**APPENDIX G:
COMMENT LETTERS
AND RESPONSE ON THE DEIS**

RE: North Rochelle Coal Lease
Application (WYW127221)
DEIS

SPECIFIC COMMENTS AND RECOMMENDATIONS ON THE NORTH ROCHELLE COAL LEASE APPLICATION DEIS

RESPONSES TO COMMENTS RECEIVED ON NORTH ROCHELLE DEIS

AIR QUALITY MONITORING SITES

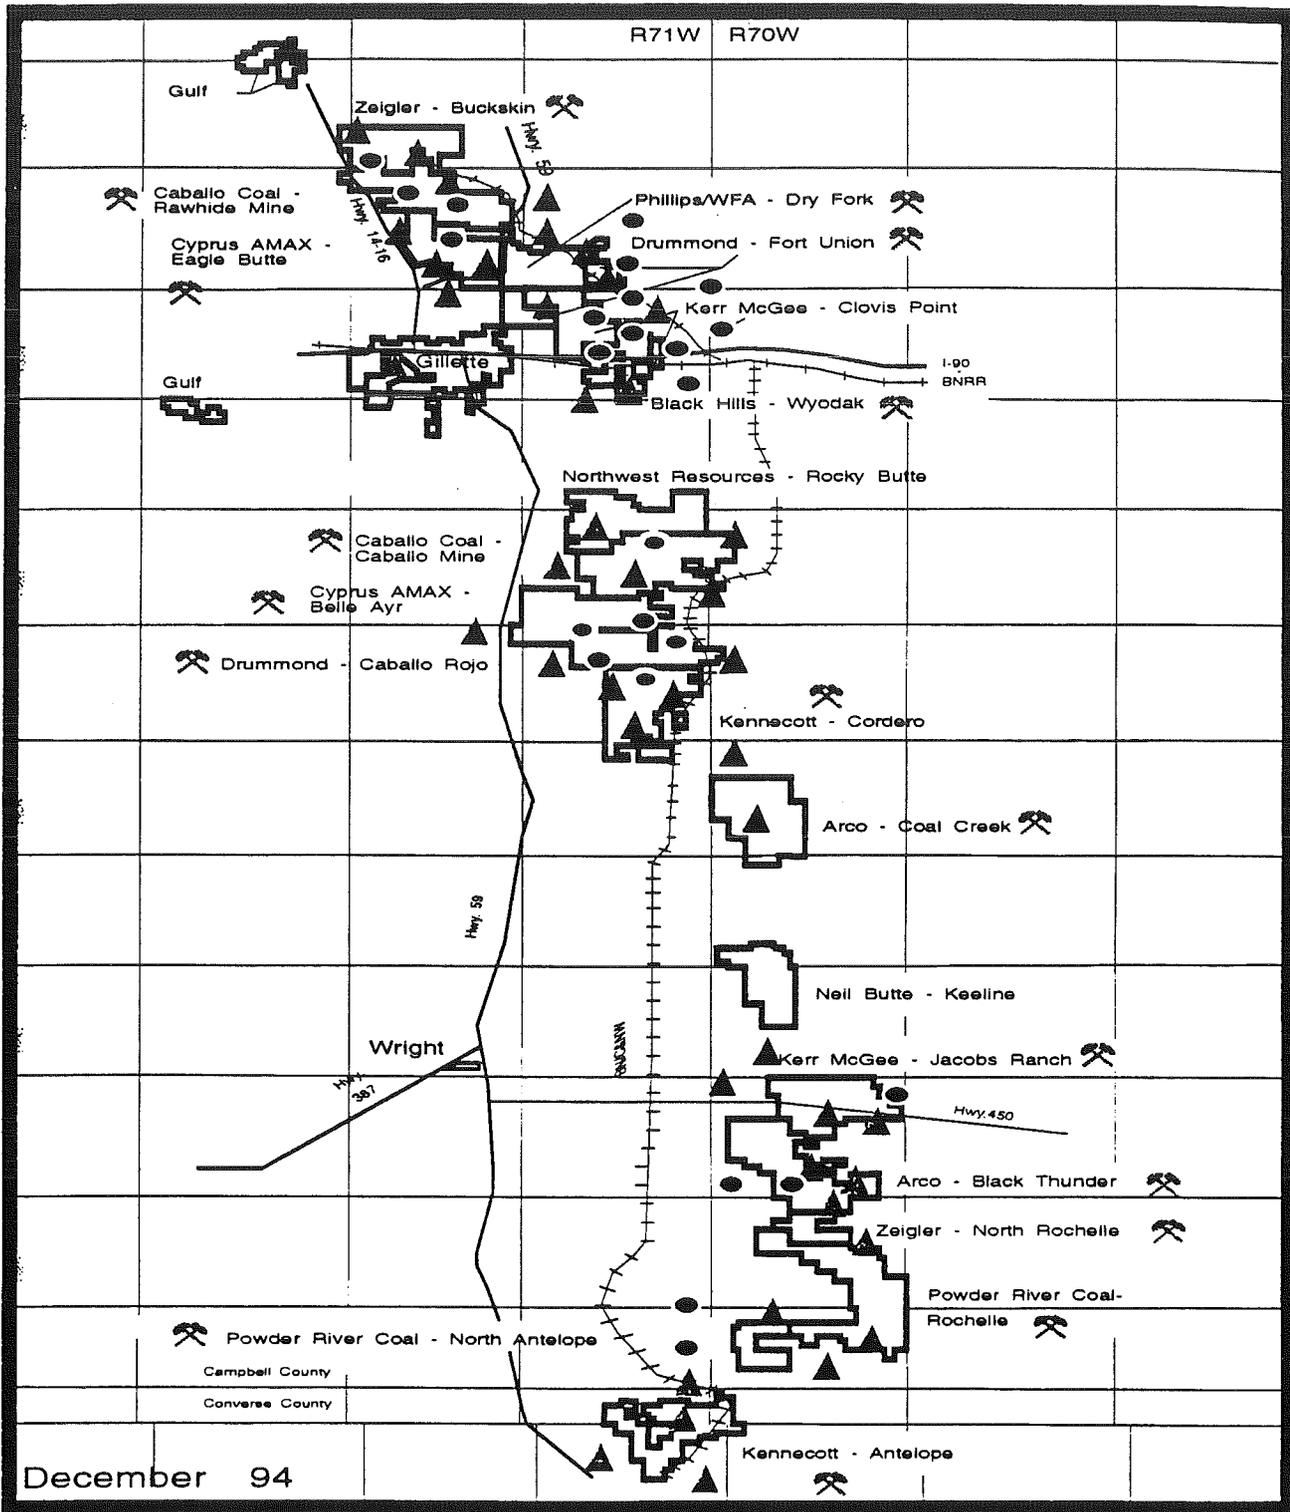
4. Section 3.5 AIR QUALITY, has no meteorological wind data. The first paragraph on page 3-10 states that average annual particulate levels have remained relatively constant even though coal production has increased. It would be helpful to know the location of Basin Mine Monitors and the Gillette SLAMS with respect to the mining locations. Also, the percentage of the year that wind direction is such that the monitors are downwind of mining operations needs to be addressed.

Recommend that a wind rose representative of the assessment area be included in Section 3.5. Section 3.5 should include a figure showing the location of the monitors with respect to current mining operations.

4. A summary of wind data and other meteorological information about the project area is included in Section 3.1 of the draft and final EIS. A wind rose for this area is included as figure 3.2 in the FEIS.

Mine operators must comply with EPA and Wyoming Department of Environmental Quality, Air Quality Division (WDEQ/AQD) monitoring and reporting requirements. Placement of air quality monitors is determined by WDEQ/AQD and the mines. A map showing the location of air quality monitors at the Powder River Basin mines in December 1994, is included with this response.
